SUBJECT: VOGTLE ELECTRIC GENERATING PLANT, UNITS 1 AND 2 RE: ISSUANCE OF AMENDMENTS (TAC NOS. MA7703 AND MA7704)

The Nuclear Regulatory Commission has issued the enclosed Amendment No. 112 to Facility Operating License NPF-68 and Amendment No. 90 to Facility Operating License NPF-81 for the Vogtle Electric Generating Plant, Units 1 and 2. The amendments consist of changes to the Technical Specifications (TS) in response to your application dated October 4, 1999.

SAFETY EVALUATION BY THE OFFICE OF NUCLEAR REACTOR REGULATION
RELATED TO AMENDMENT NO. 112 TO FACILITY OPERATING LICENSE NPF-68
AND AMENDMENT NO. 90 TO FACILITY OPERATING LICENSE NPF-81
SOUTHERN NUCLEAR OPERATING COMPANY, INC., ET AL.
VOGTLE ELECTRIC GENERATING PLANT, UNITS 1 AND 2
DOCKET NOS. 50-424 AND 50-425

Figure 5.5.6-1 Schedule of Lift-Off Testing for Two Containments at a Site

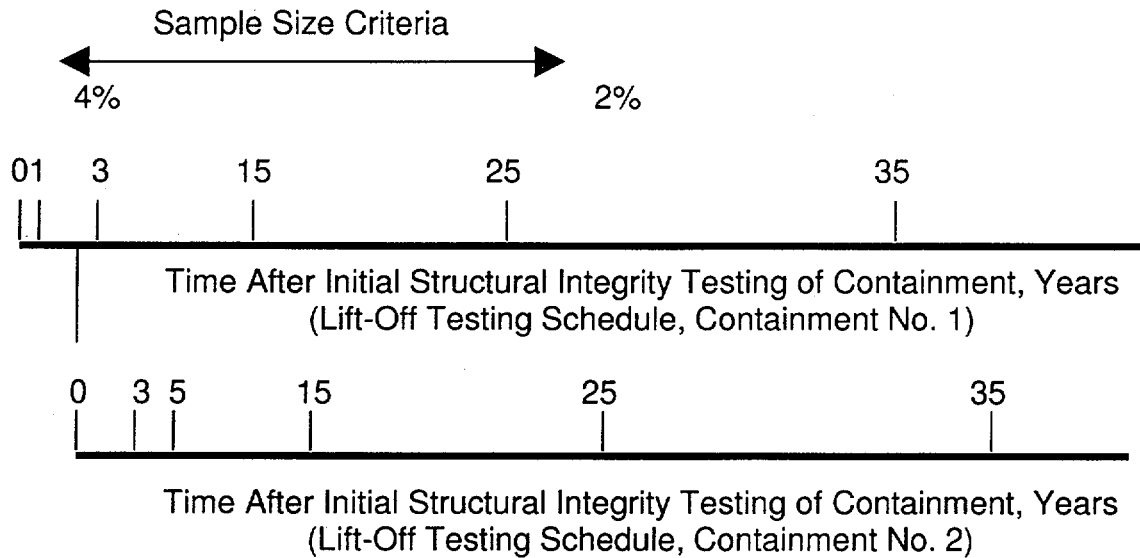
1. Number of Tendons Detensioned - Only one vertical and one horizontal tendon are detensioned on Unit 1 each time lift-offs are performed on Unit 1 per figure 5.5.6-1. Only one vertical or one horizontal tendon is detensioned on Unit 1 each time lift-offs are performed on Unit 2 per figure 5.5.6-1.
2. Concrete Inspection - The concrete adjacent to the vertical tendons cannot be inspected due to steel plating covering the concrete.
3. The areas adjacent to the tendons are inspected during the tendon surveillance instead of during the ILRT.

- a. The containments are identical in all aspects such as size, tendon system, design, materials of construction, and method of construction. The tendon system for Unit 2 does not provide for detensioning. Detensioning can be performed only on the Unit 1 tendon system.
- b. The 1-year inspection for Unit 2 will consist of a visual inspection only. No lift-off testing will be performed on Unit 2 until the 3-year inspection.
- c. There is no unique situation that may subject either containment to a different potential for structural or tendon deterioration.
- d. The Unit 1 and Unit 2 surveillances may be performed back-to-back to facilitate detensioning of Unit 1 tendons during the Unit 2 surveillance.
